Joint Regional Planning Panel (Sydney East Region)

| JRPP No. | 2015SYE011 |
| DA No. | DA/320/2013/B |
| Proposed Development | Section 96 modification of the approved development (S96B) by replacing the supermarket at ground floor level with 4 retail tenancies, total reduction of 180sqm in approved gross floor area, changes to basement parking configuration including modification to access ramp and circulation, 8 new 2 bedroom residential units at mezzanine level, changes to loading dock configuration, reduction in total number of car parking from 283 to 200, and increase the overall building height to RL53.00. Original consent: Demolition of the existing buildings and construction of a new part 6 and part 7 storey mixed use development comprising of ground floor retail space, 100 residential dwellings, 3 basement levels of parking, associated site and landscaped works |

Figure 1 shows the S96B building envelope, the location of the additional apartments (outlined in green) , ground level parking (bounded in yellow) and for comparison purposes the originally approved building envelope (shaded grey)

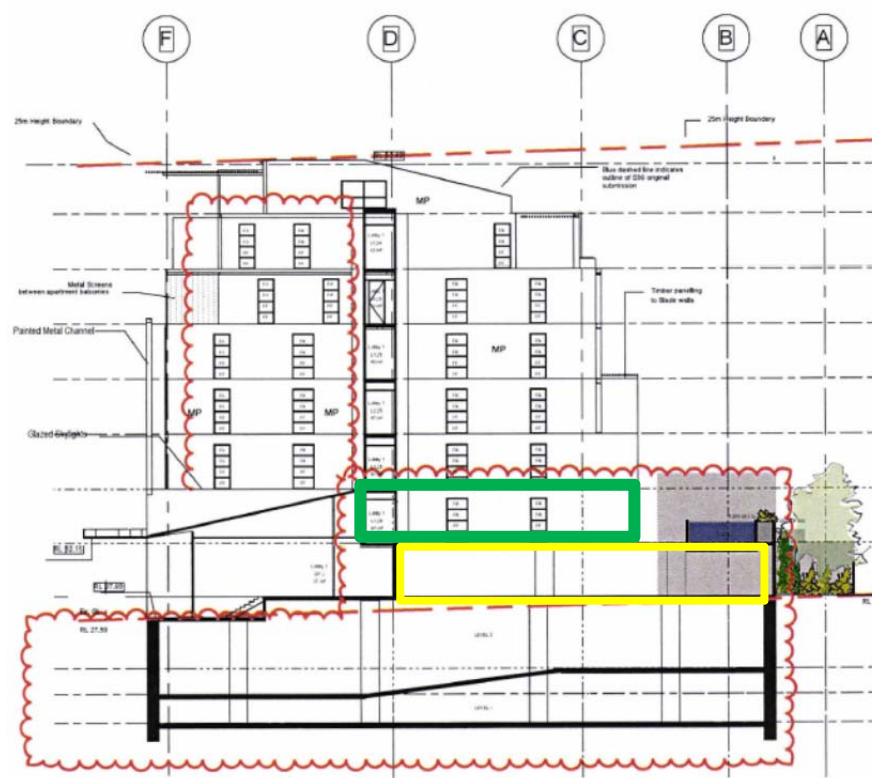
It is proposed to increase the number of apartments within the building from 113 to 121. The additional floor area is offset by the loss of the supermarket. This has been achieved by removing the supermarket and incorporating upper level 3 apartments over portions of the enlarged retail tenancies and proposed ground level parking area (see Figure 1 below). The additional apartments result in additional floor area however there will be an effective reduction in the buildings bulk and scale when viewed from the neighbouring properties at the rear.

- In terms of built form and envelope, this part of the S96B modification reduces the overall building envelope at the rear (as previously identified in Figure 1) and
- The provision of four retail tenancies along Anzac Parade frontage will maximise street level activity by breaking up the large glazed shopfronts into sections associated with separate uses ensuring greater levels of visual interest thus contributing positively to the Kensington Town Centre.
- Reduction in noise and amenity impacts with servicing a large supermarket.
